**THE REGIONAL DISTRICT OF NANAIMO
 WHITE HEATHER LANE FIREWATER STORAGE TANK - ACCESS**

Addendum # 1

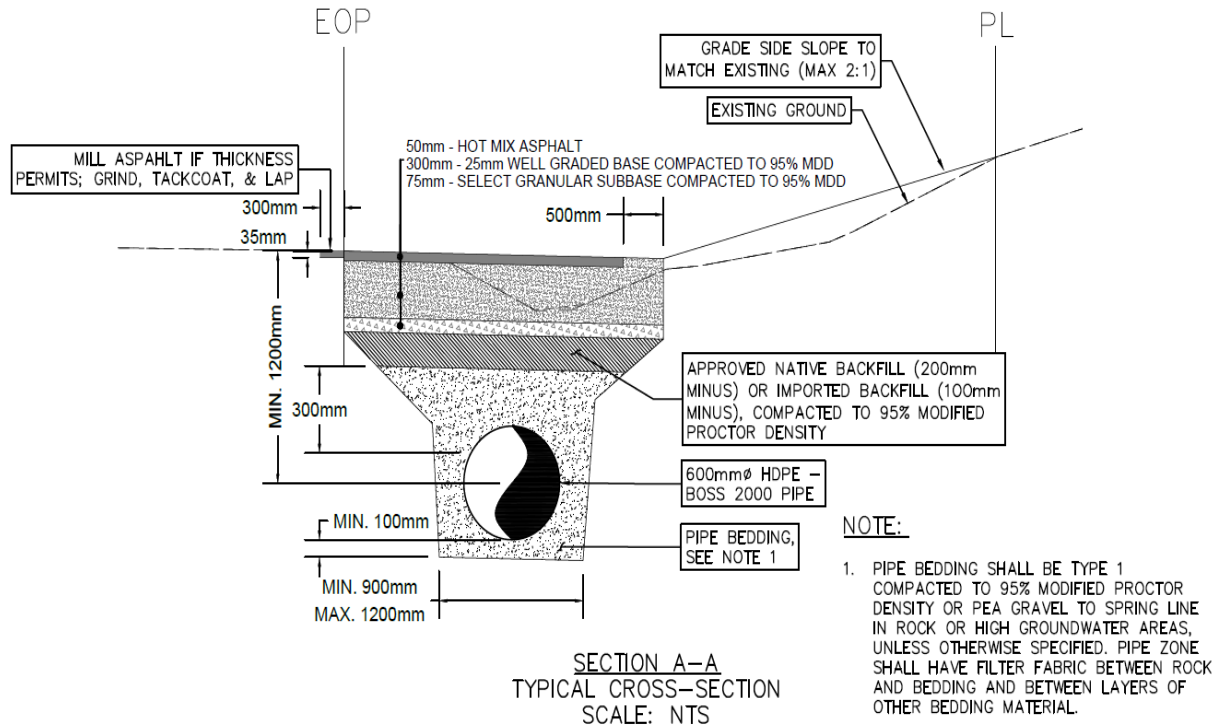
5. Can you please advise if the culvert is supposed to be backfilled with certain material i.e. Type I bedding?

Answer: Please refer to the updated Section A-A below.
